TEC-1F Errata 2021-09-30

PCB Version: TEC-1F-3

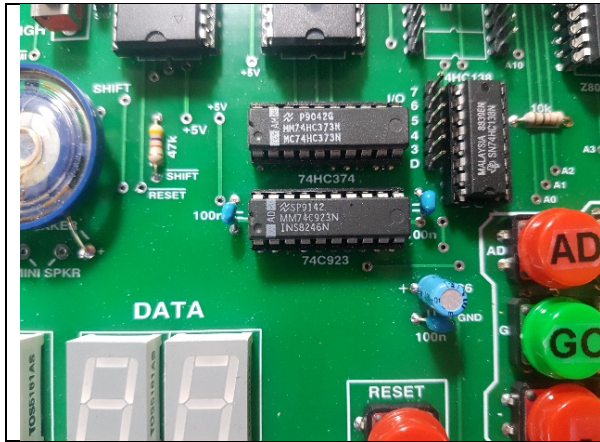
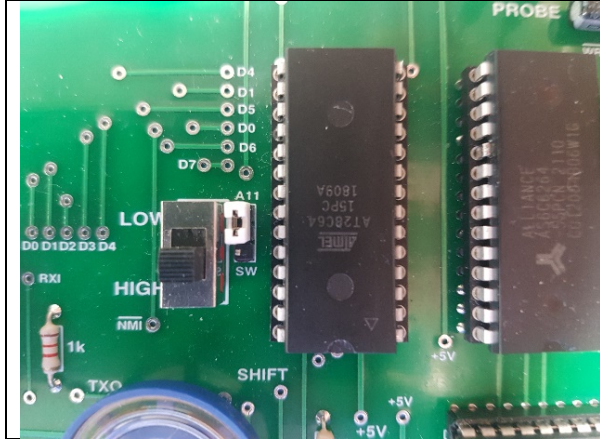
The IC above the 74C923 should be a 74HC373(as shown) and not a 74HC374 as labelled.

The switch and jumper are unnecessary unless you plan on using 2716 or 2732 EPROMs. you must link the jumper centre pin and A11 pin for correct operation with 8k devices.
